CLEARFIELD CITY COUNCIL
AGENDA AND SUMMARY REPORT
April 27, 2021 – WORK SESSION

TO: Mayor Shepherd and City Council Members
FROM: Eric Howes, Community Services Director
MEETING DATE: April 27, 2021
SUBJECT: Freeway Interchange Conceptual Design

SUBJECT: Discussion and Possible Action on **FSP 2021-020027**, a final subdivision plat request by Shelly Eskelson for a 9-Lot single-family subdivision at the subject location. **Location:** 50 West 200 South (TIN's: 12-020-0062). **Parcel Area:** 1.5 acres. **Zone:** R-1-6 (Residential). **Planner:** Brad McIlrath (**Administrative Action**).

Attn: Brad McIlrath, Senior Planner
Proj: **Weaver Subdivision**
Subj: Review #2 – Review comments for Plat & Improvement Drawings

Demolition

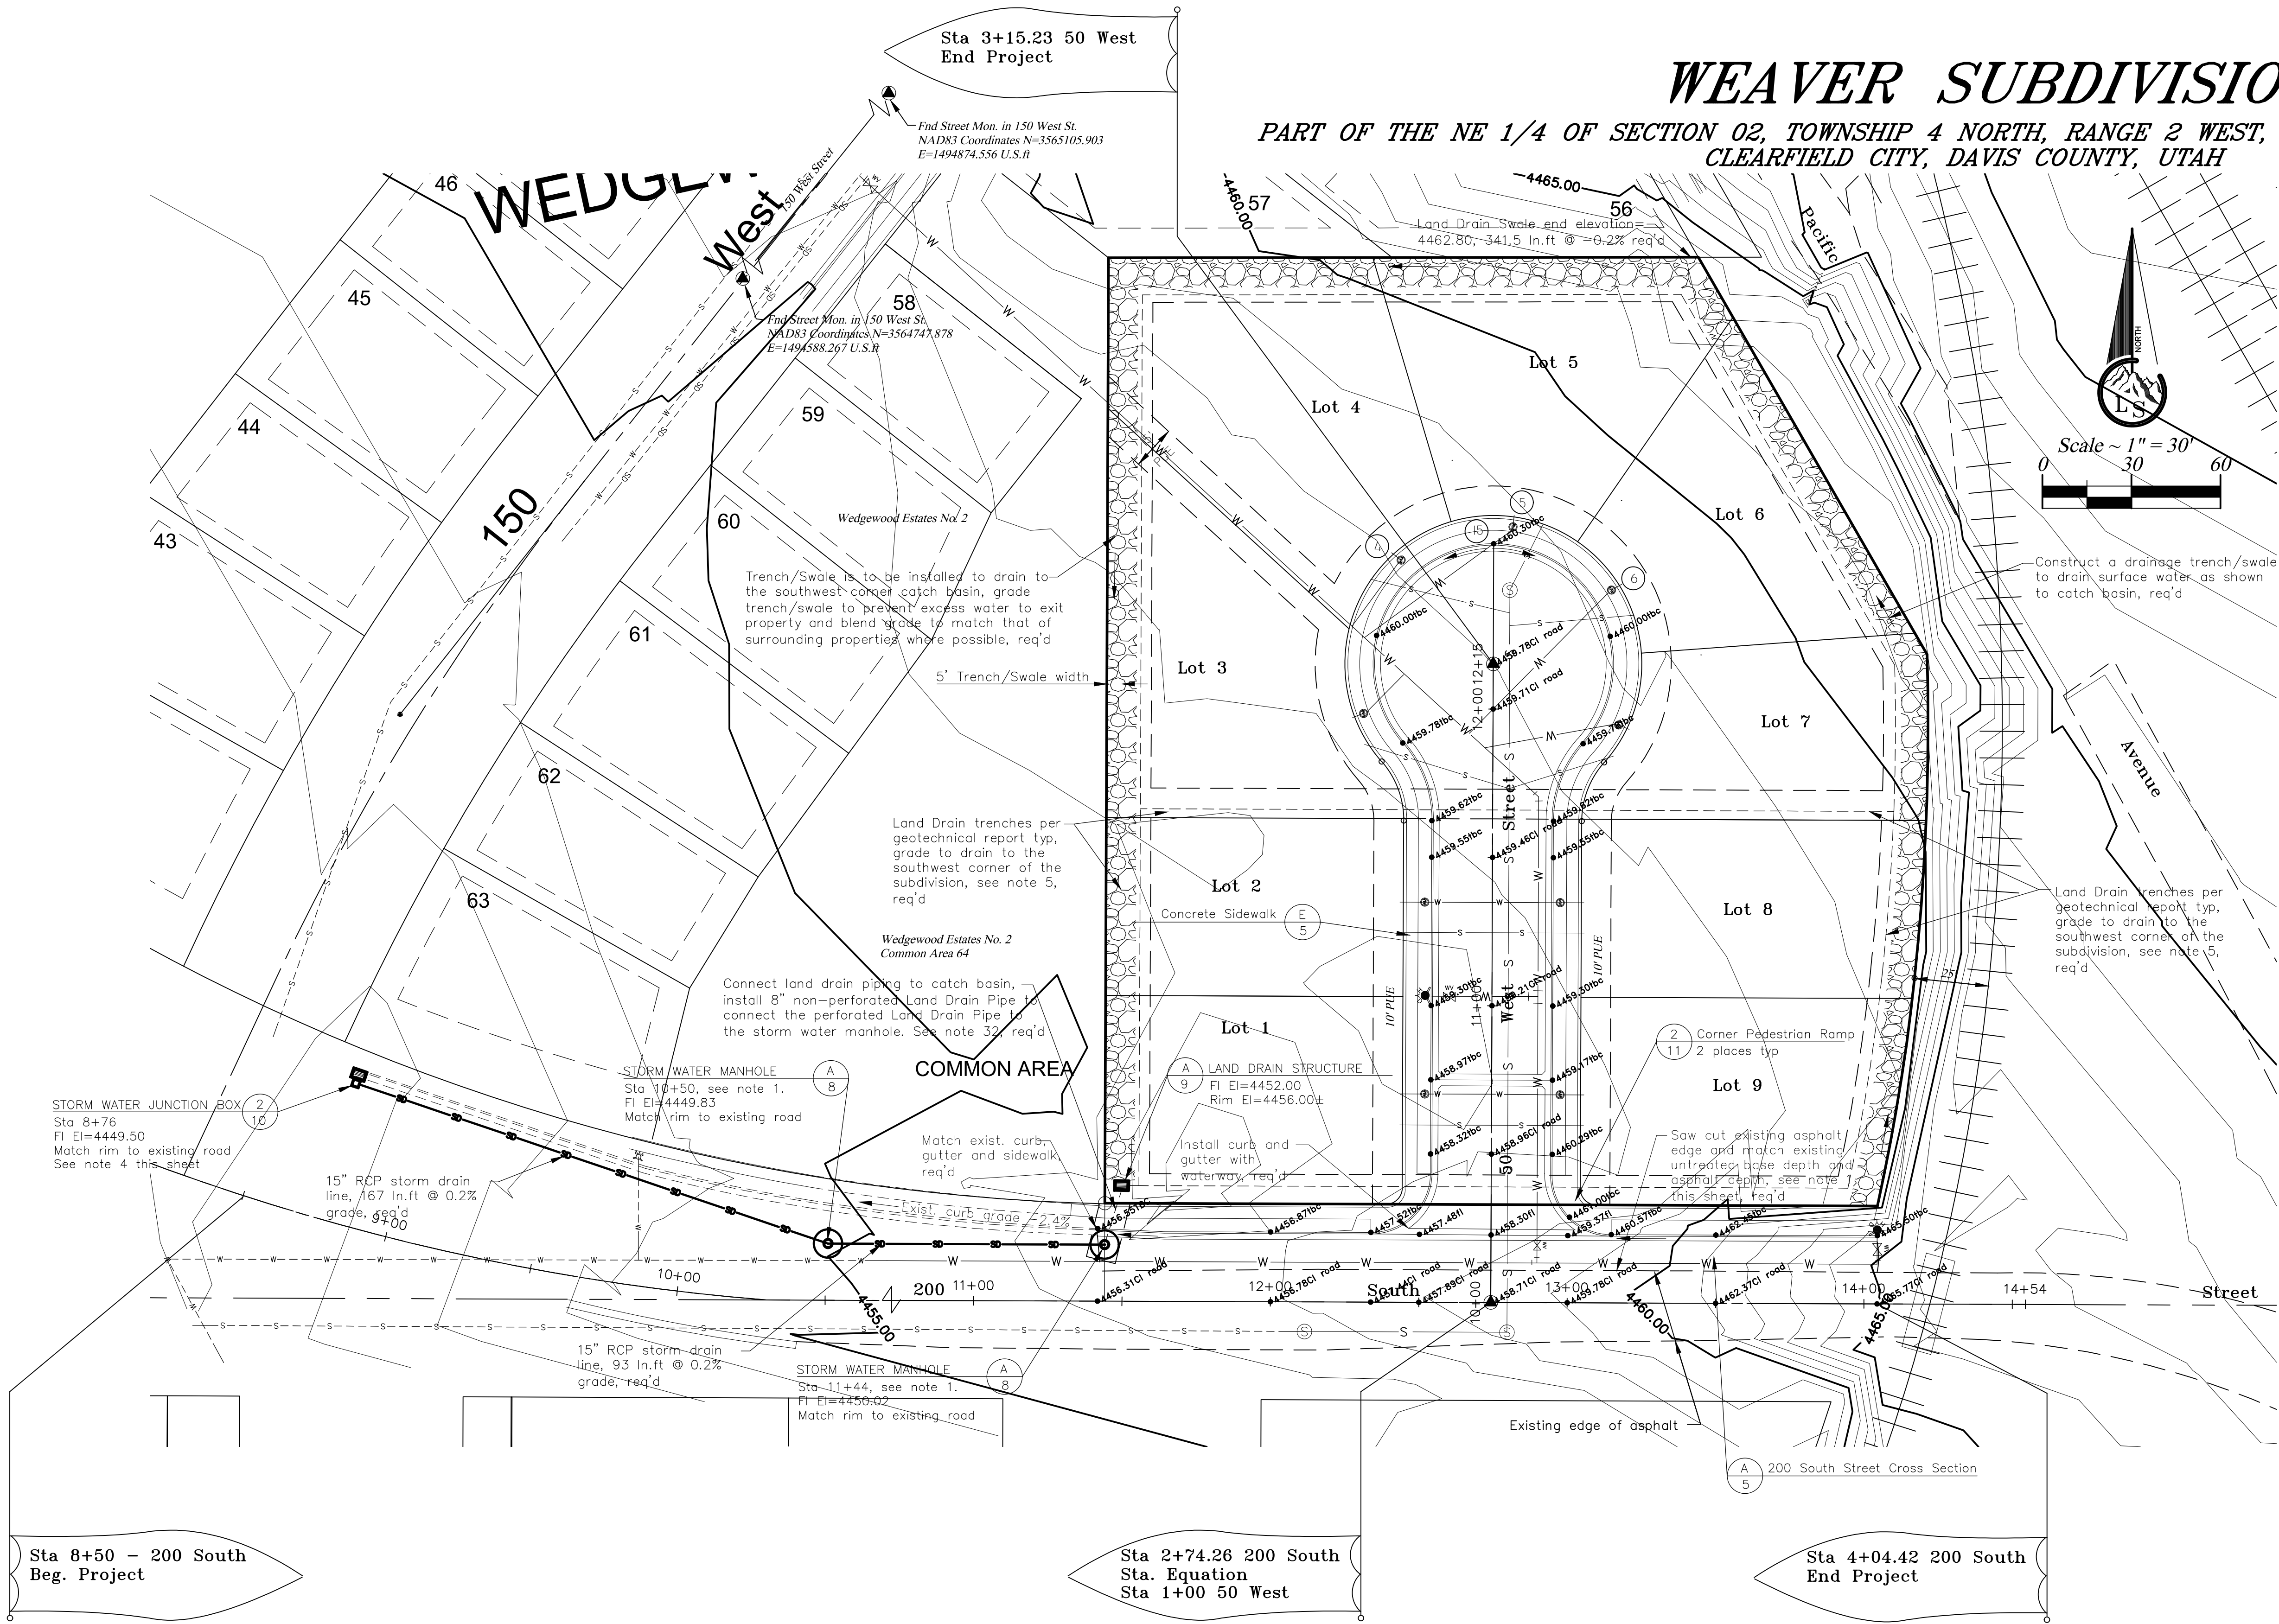
3. Demolition Plan:
 - Note #6 will need to be corrected – All existing utilities being removed, and abandon must be capped and disconnected at the location of the main service line (not just **near** the main line).

- The current drawing date is needed under the title block of the drawing.
4. Grading Plan:
 - On the curb & gutter design show the curb & gutter slopes adjacent to the directional arrows (minimum slope approved is 0.5%).

Sewer Details

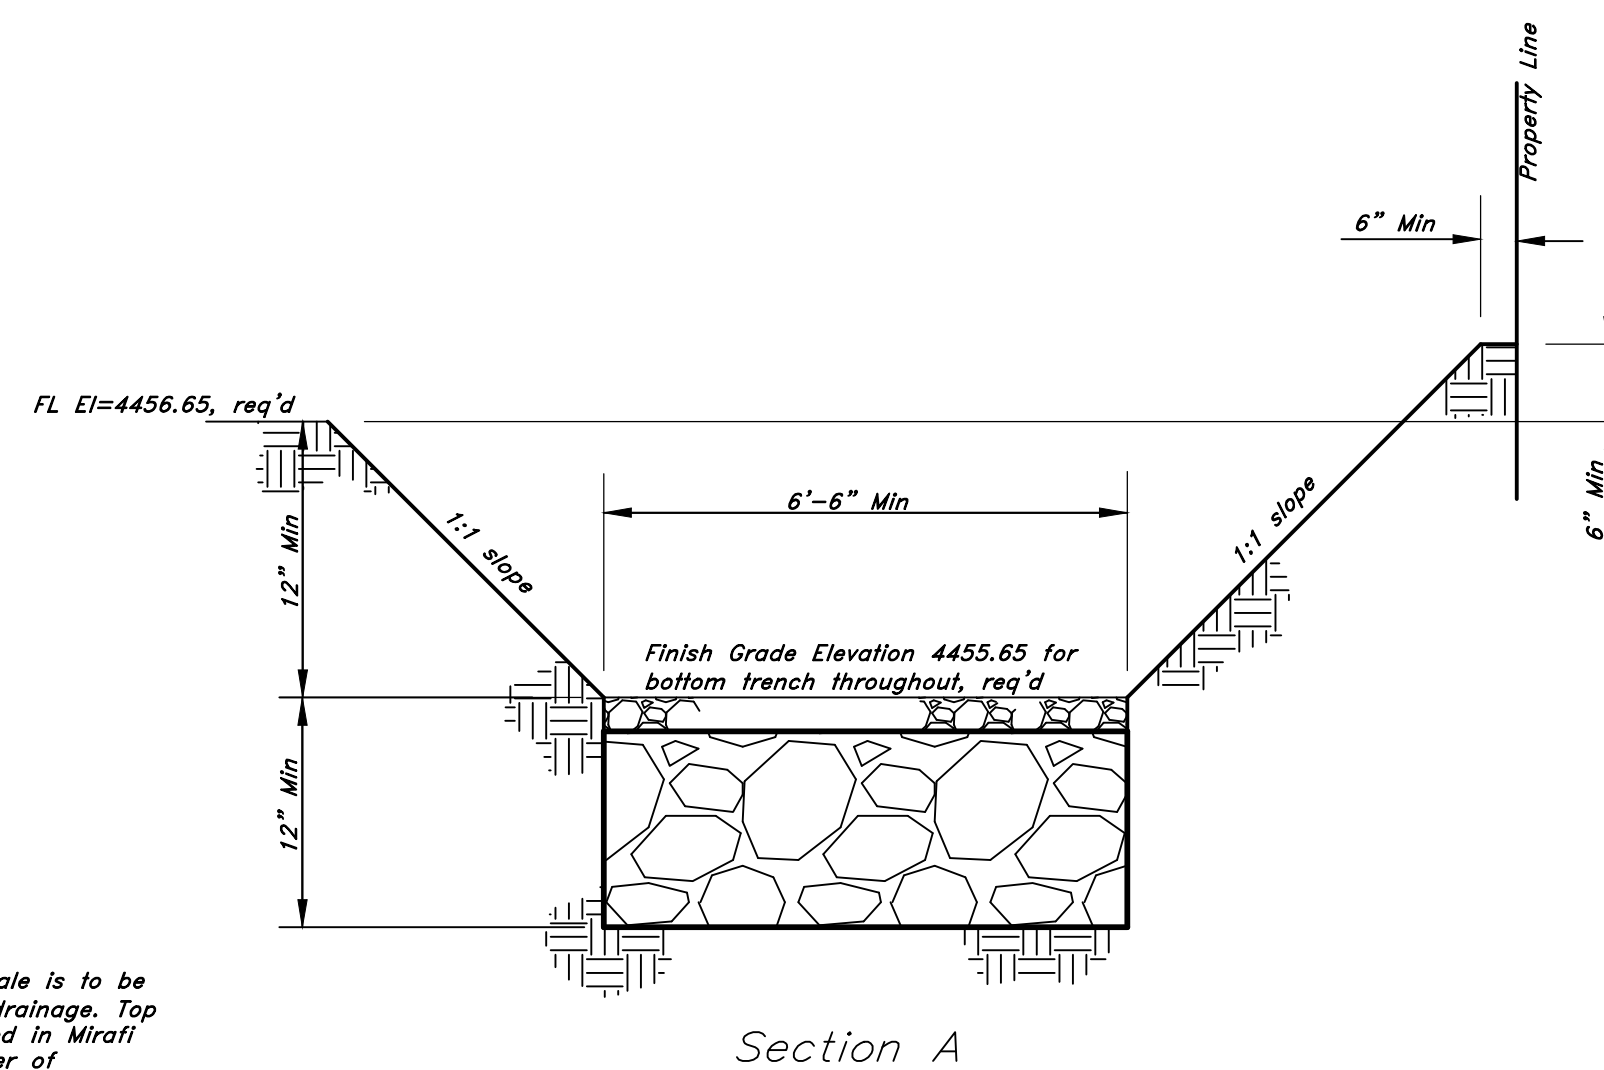
- Three culinary water control gate valves are required at the intersection of 50 West Street / 200 South Street
- An additional culinary water control gate valve will be required at the waterline angle at the front of the cul-de-sac.
- The sanitary sewer service lateral for lot #5 will need to be attached to the 8" main pipeline as a wye connection rather than into the manhole located in the cul-de-sac.
- The fire hydrant control gate valve must be attached to the water main line tee connection (adjust the drawing accordingly).
- A concrete grade ring (4"- thick and 12"- wide) needs to be installed around the collection box on the westerly side of lot #1.
- A note on the drawings will need to state that all culinary waterlines are to be DR-18.

9 TRENCH/SWALE STRUCTURE
N.T.S.

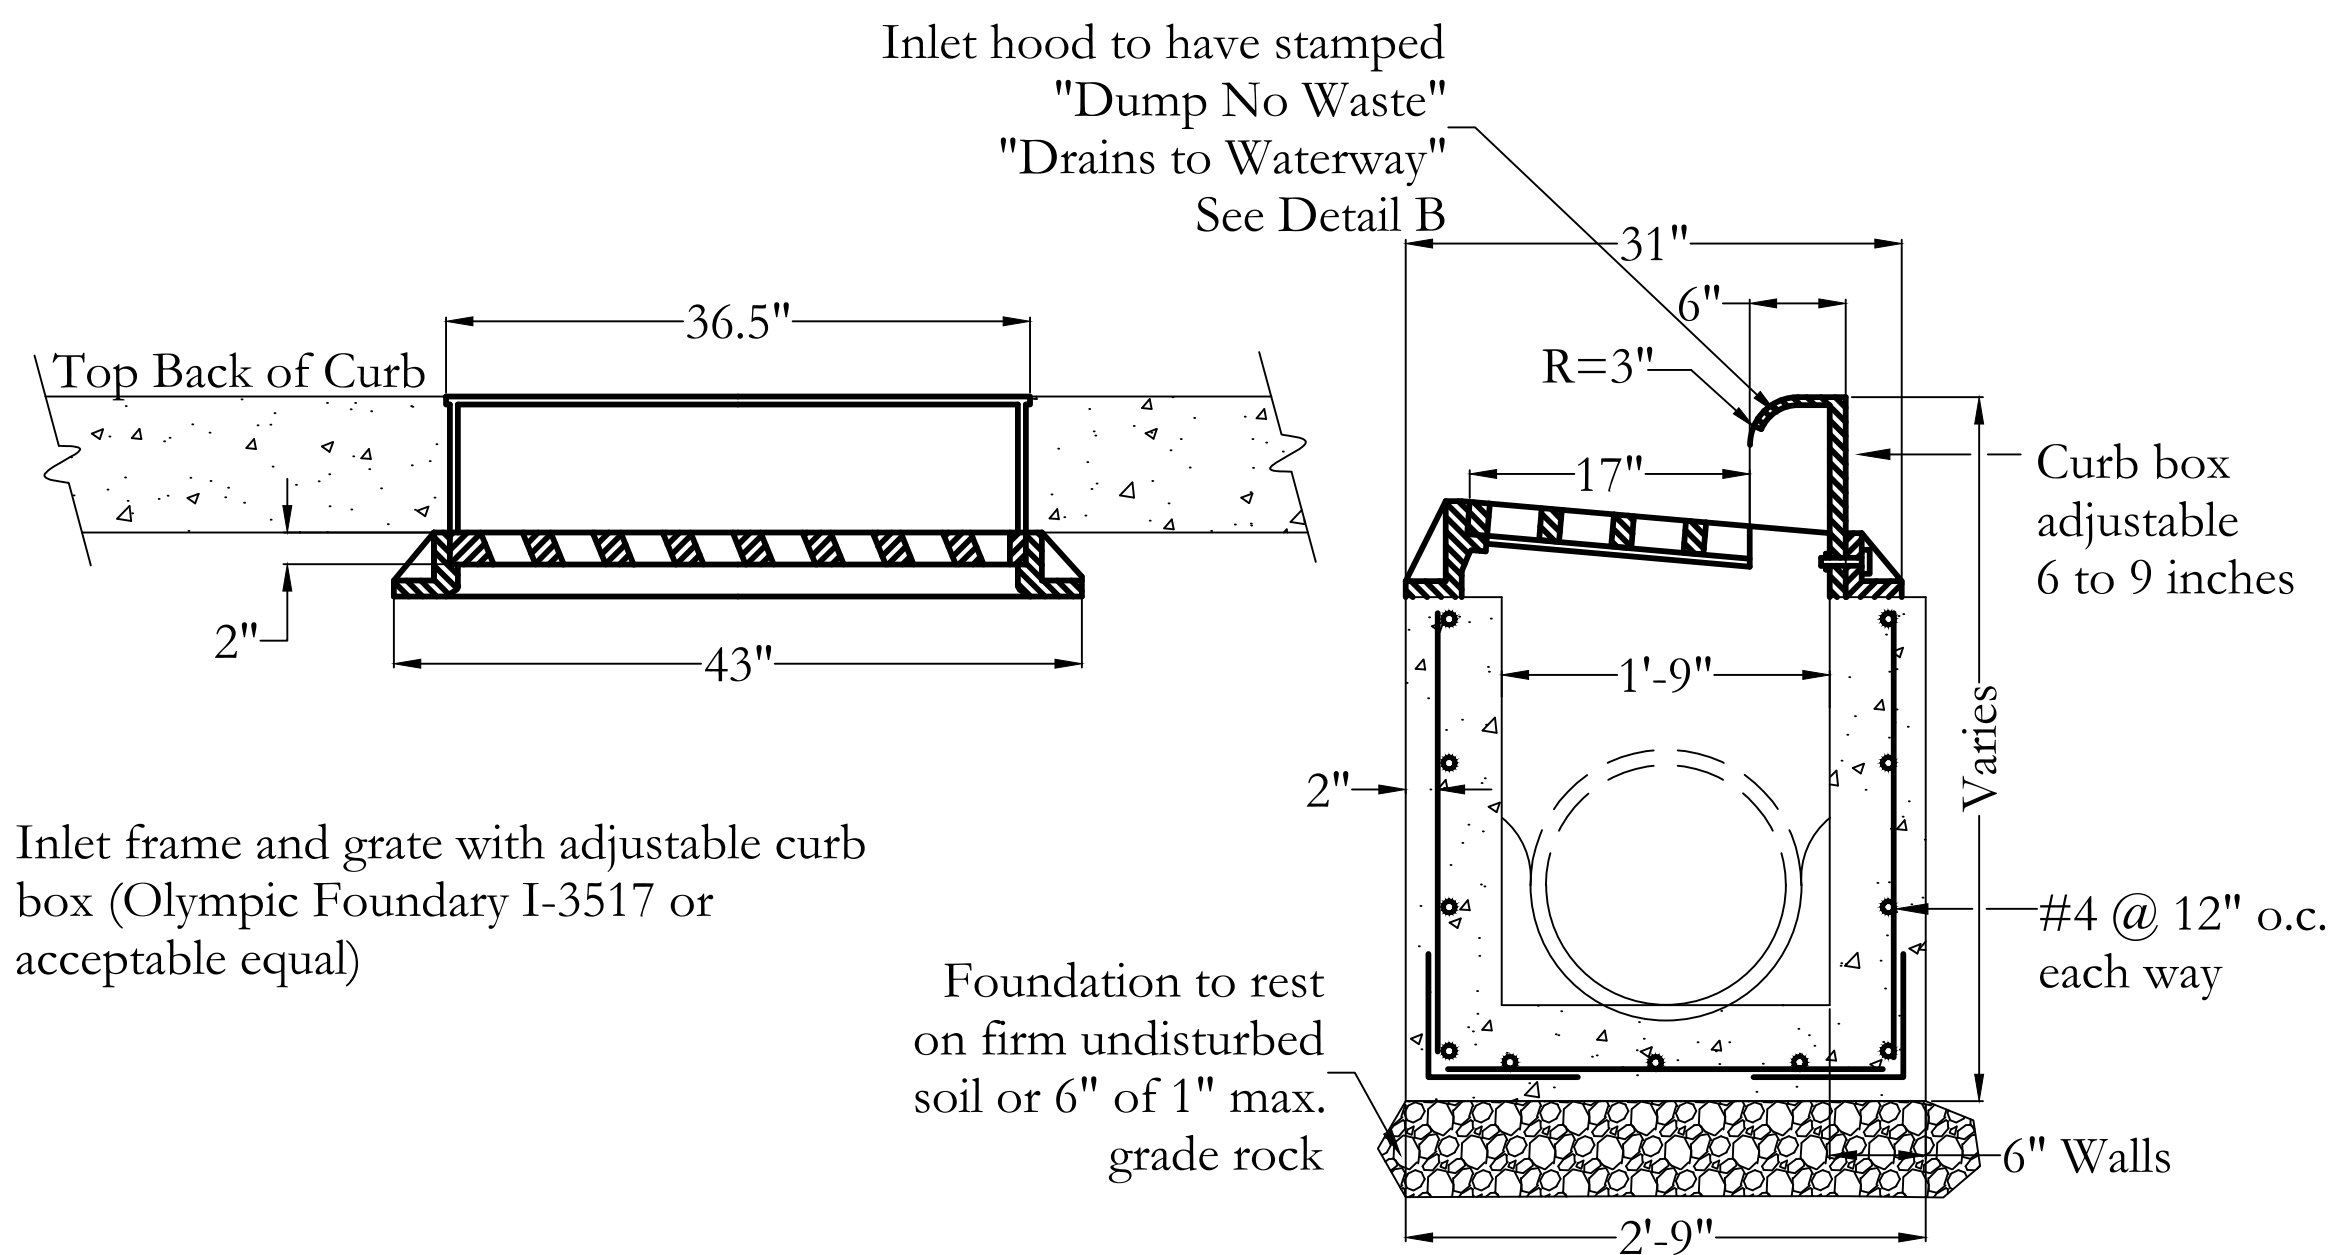
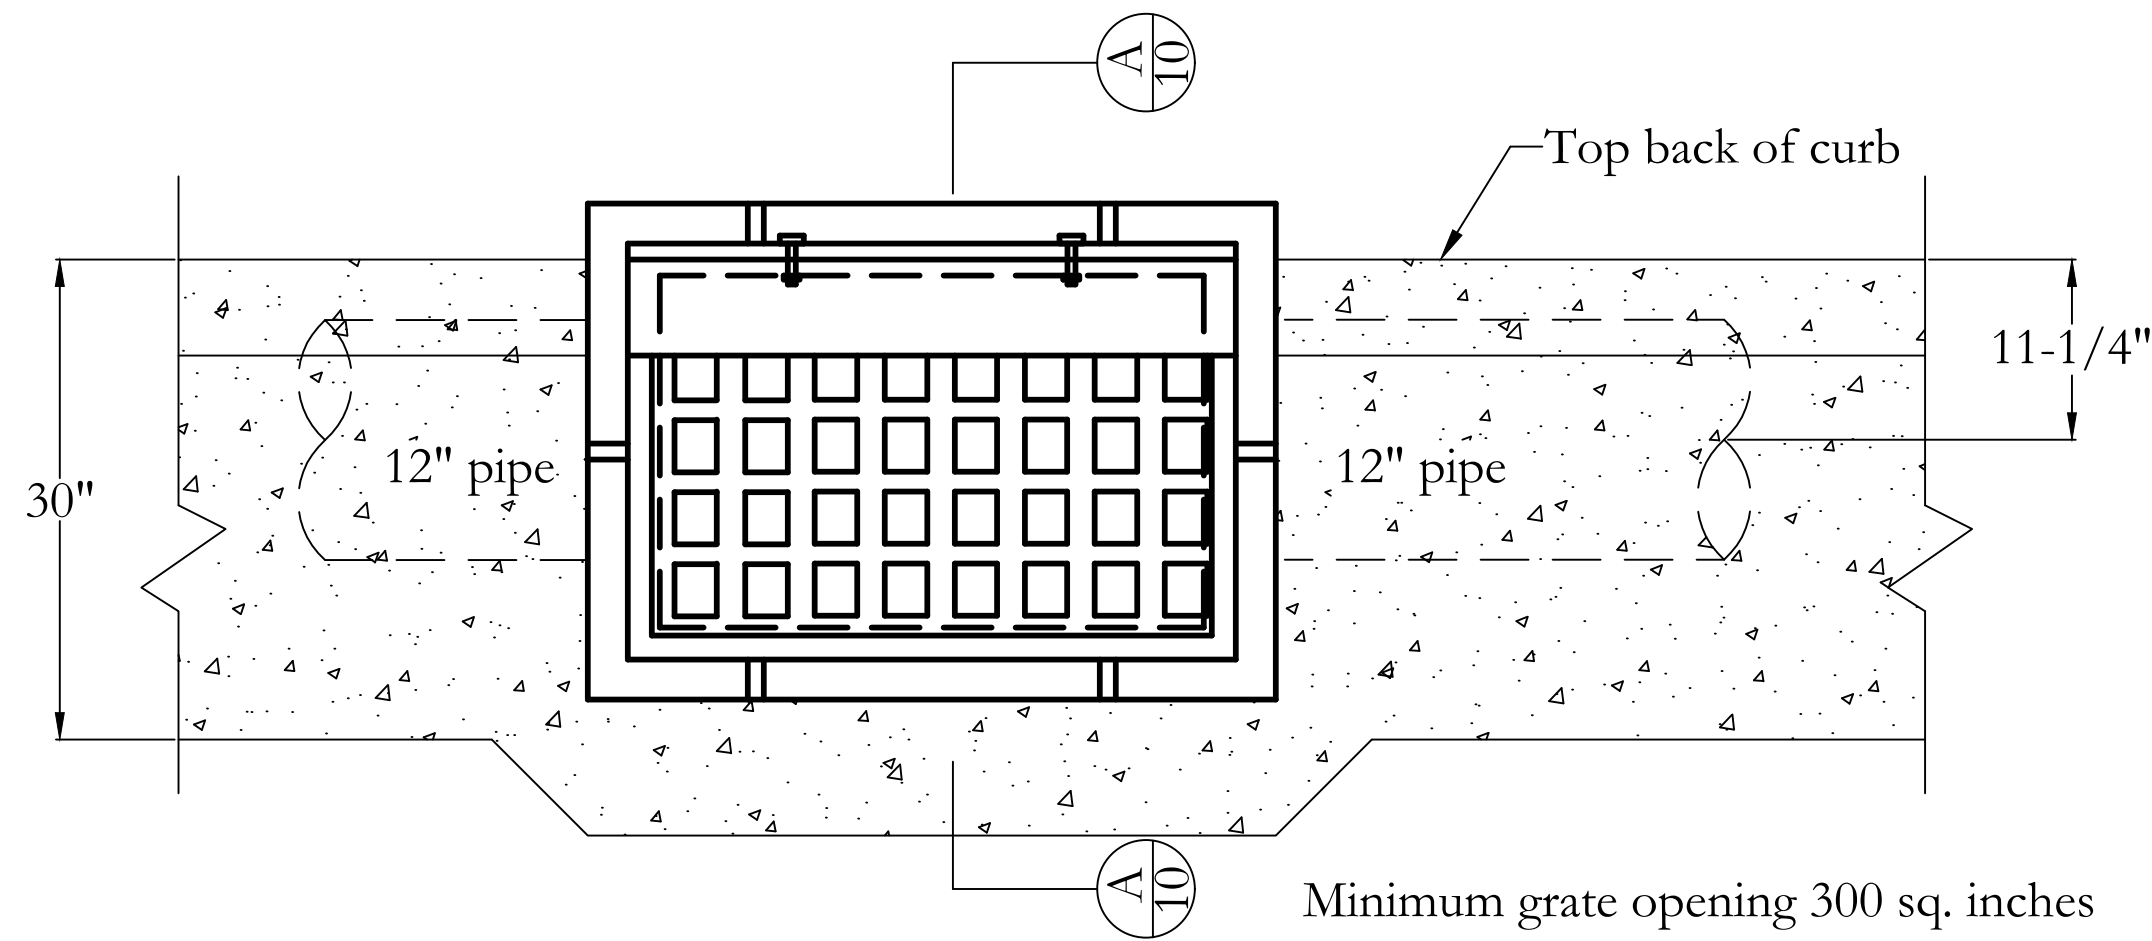
- Modify the 5' wide trench/swale design. Show the proposed trench/swale slopes with any grade changes and the flow line elevations along with the top of trench swale around the perimeter of the subdivision. My opinion is that the 1:1 side slope is too steep, I would recommend 1:2 ½.
